# R. H. McCOMB ADDITION

Re: S/D97-93 -- One-Step Final Plat of R. H. McComb Addition

**STAFF REPORT**

**CASE NUMBER:** S/D 97-93 - R.H. MCCOMB ADDITION

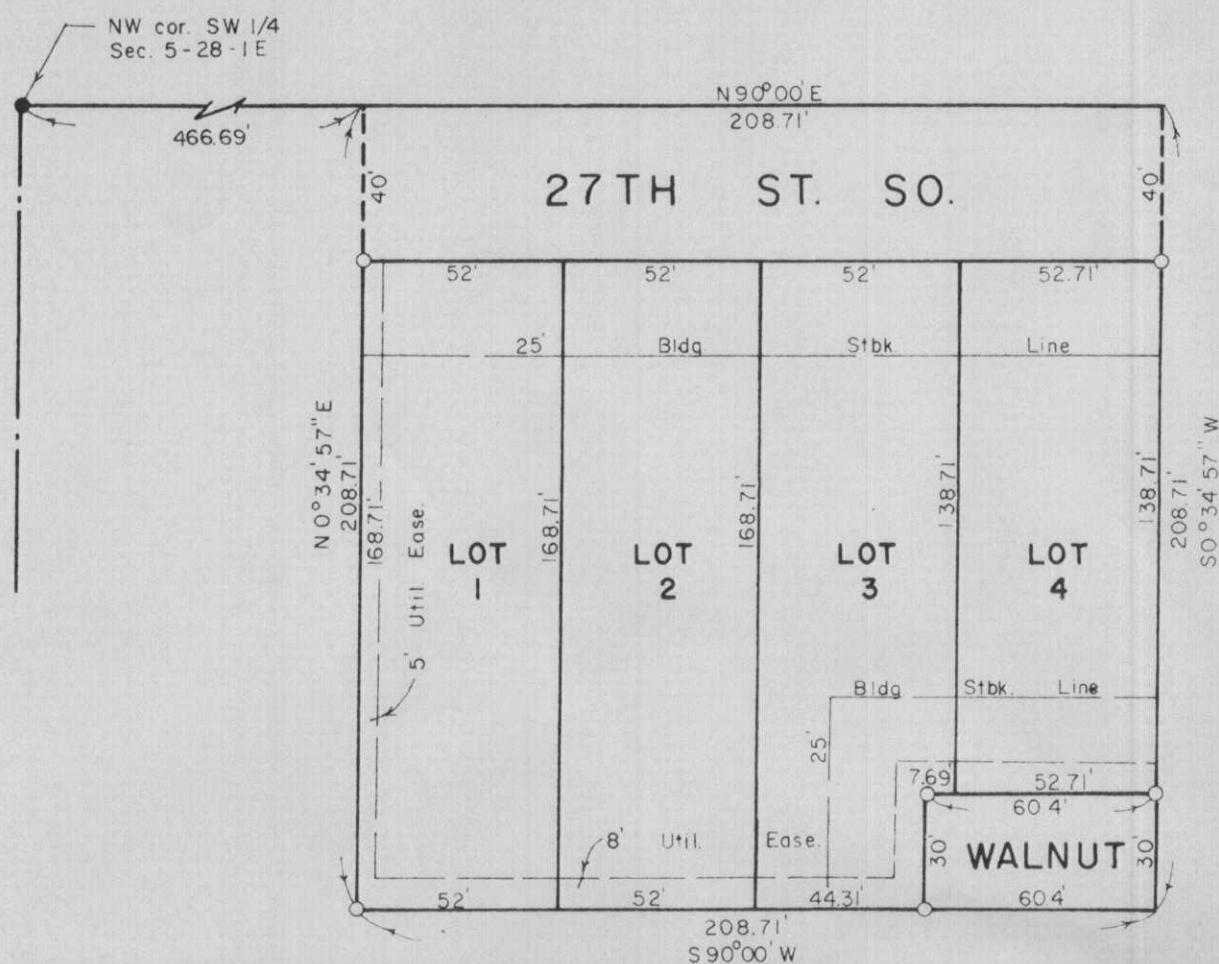
- C. The reference tie point to the section corner needs to be corrected to denote the range as "1E".
- D. This property is within a zone identified by the City Engineers' office as likely to have groundwater at some or all times within 10 feet of the ground surface elevation. Building with specially engineered foundations or with the lowest floor opening above groundwater is recommended, and owners seeking building permits on this property will be similarly advised. More detailed information on recorded groundwater elevations in the vicinity of this property is available in the City Engineers' office.

- E. City Engineering needs to comment on the status of the applicant's drainage plan. The drainage plan is approved.
- F. The lot depth to lot width ratio of 2.5 to 1 is exceeded by each of the four lots and a waiver is needed for the approval of this plat.

- G. The 15-foot setback platted from Walnut is insufficient. A 25-foot setback is required.
- H. On the final plat tracing, the Chair of the MAPC should read Richard Lopez.

- I. Since this plat is dedicating right-of-way for Walnut, the face of the plat shall clearly indicate such a dedication and appropriate language included in the plat's text. *A paving guarantee will be required for the T-type turnaround which will be held until Walnut is paved.*

- J. *Traffic Engineering and City Fire Department* needs to comment on the T-type turnaround proposed for Walnut Street which currently serves ten existing single-family dwellings south of this plat and measures 460 feet in length. *City Engineering indicates that the location of the T-type turnaround will probably necessitate a sanitary sewer easement for sewer service to Lot 4; and will meet with the applicant to discuss this issue. Traffic Engineering and Fire Department have indicated the acceptability of the turnaround.*
